Subject: Section 7 Determination - Forest School Outfall

Allegheny River
C.O.E. Application #200201119, (Forest School Outfall)
Section 7(a) Evaluation, Wild and Scenic Rivers Act

USDA Forest Service, Allegheny National Forest,
Administering Agency

Figure 4 – Headwall Detail Plan

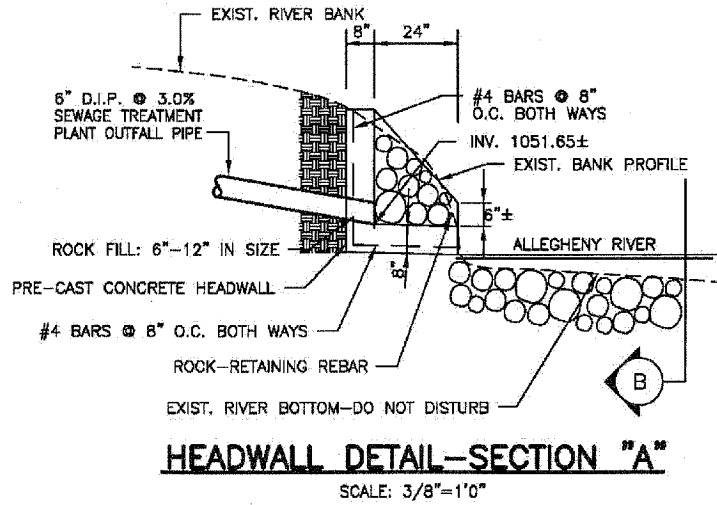
The outflow pipe will end at a pre-cast concrete headwall installed at the river's edge facing almost due south. See Figure 3 – Sanitary Sewer Profile "B". This location is in the side of a small cove where an ephemeral stream enters the river. See photos 2 & 3 – Headwall location. The headwall will have native river rocks placed in the structure to provide a natural visual appearance during low water. The plans state that the headwall will be set with its outfall at or slightly above the current (10/4/02) water level. See figures 4, 5, & 6 – Headwall Detail Plan and Sections.

assure that the rock harmonizes with the natural character of the shoreline, native river rock should be used.

Comment: Appropriate mitigation to protect scenic value.

1. Use of native river rock in the headwall structure.
2. The top of the headwall elevation placed below the existing grass level.
3. Immediate re-vegetation of disturbed areas with native seed mixtures.
4. Adherence to the water quality discharge parameters set forth by the PA DEP including any specified by the US Fish and Wildlife Service.

Photo 1. Proposed wastewater discharge pipe location looking from the floodplain out across the channel. The pink flag marks the outlet location

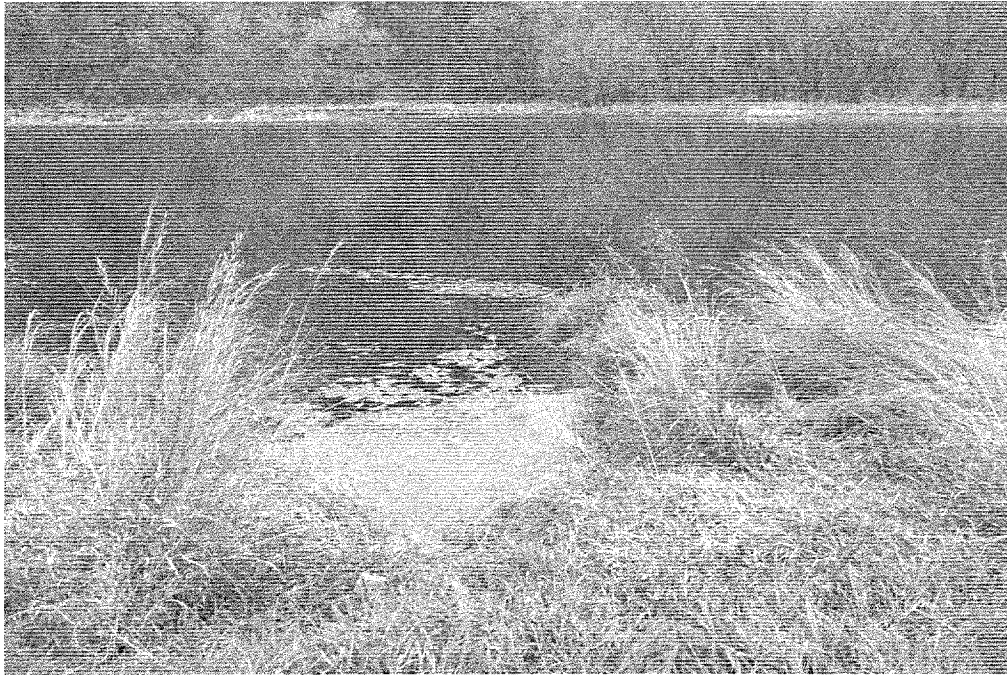
The pipeline and outflow are within the floodway of the river. The floodplain and shoreline in this location are very stable. It is gently sloping and densely vegetated with grass. See photo 1 – Pipeline Location. The area of disturbance will be 0.01 Ac. Some grass cover will be displaced in excavating the approximately 2 foot wide pipeline trench but the area will be revegetated with a native grass seed mix as per the E&S Plan.

A field visit to the site occurred on November 5, 2002, during flow conditions that were below average for that date. The flow observed on November 5, 2002 was 3,080 cfs (average flow for this day is 5,465 cfs.). The engineering plans and sections are based on the water level that existed on October 4, 2002 when the flow was 1,590 cfs, considerably lower than

our visit on Nov 5. Therefore our pictures show a much higher water level than the plans depict, a difference of 4 to 5 feet.
